AC-21-01 (Vantage Garage Standards)

Hold a public hearing and consider an appeal by Chris Weigand of the decision of the Planning and Zoning Commission on February 23, 2021 to deny the request for Alternative Compliance to the residential garage parking requirements in Section 7.1.4.1. of the Development Code for a proposed residential development located in the 3800 Block of Hwy 123.

40'X110' LOT LAYOUT EXHIBIT

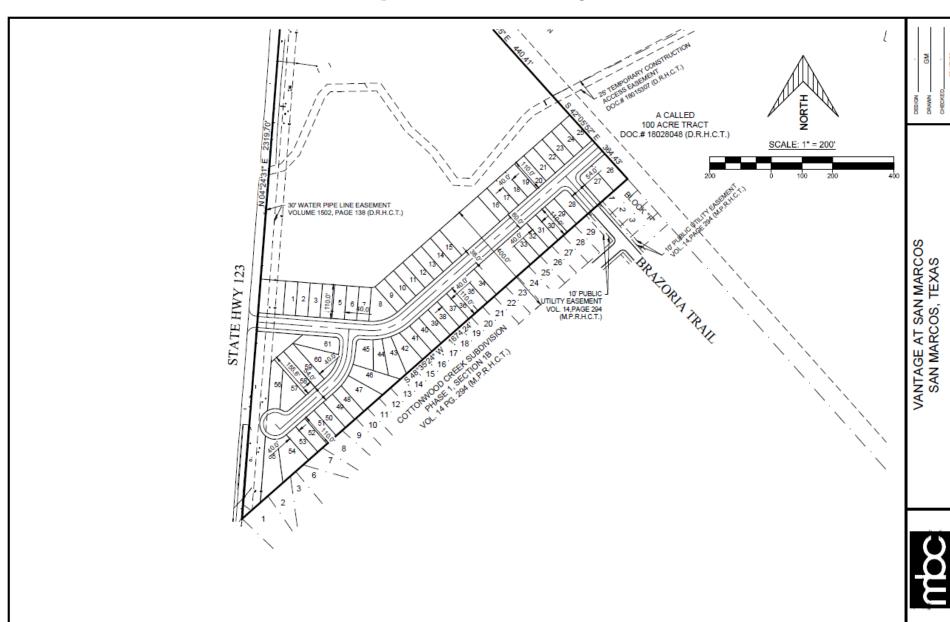
- Alternative Compliance: Residential Garage Parking Standards
- Garage Standards are applicable to the "House" Building Type in CD-2.5 Zoning
- +/- 61 residential lots
 - House Building Types
 - 40' wide residential lots

Figure 4

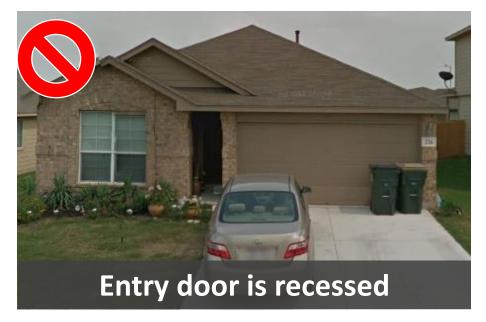
1. In no case shall the garage be the front most protrusion of the house, but it may be flush. For the purposes of this condition, a front porch is considered a protrusion of the house;

This alternative compliance request will allow Figure 2, 3, and 4 Porch Porch Garage Garage Garage Conditioned Conditioned area of house area of house Conditioned area of house Figure 3 Figure 2 Figure 4

Garage is behind the front protrusion, such as a porch

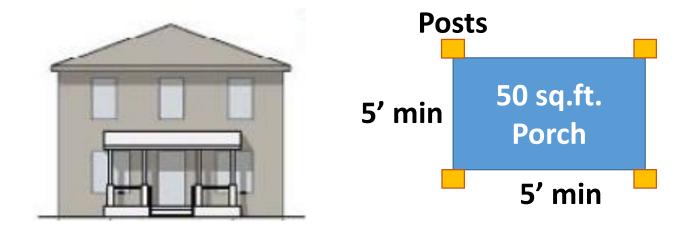
3. A covered front porch shall be required on a minimum of 50% of the homes. The front porch shall be a minimum of 5 feet of clear space in all directions (no obstruction from porch posts) and shall have a minimum area of 50 square feet;

4. The total width of the garage door (including any center column between two garage doors) shall not exceed more than 55% of the width of the house;
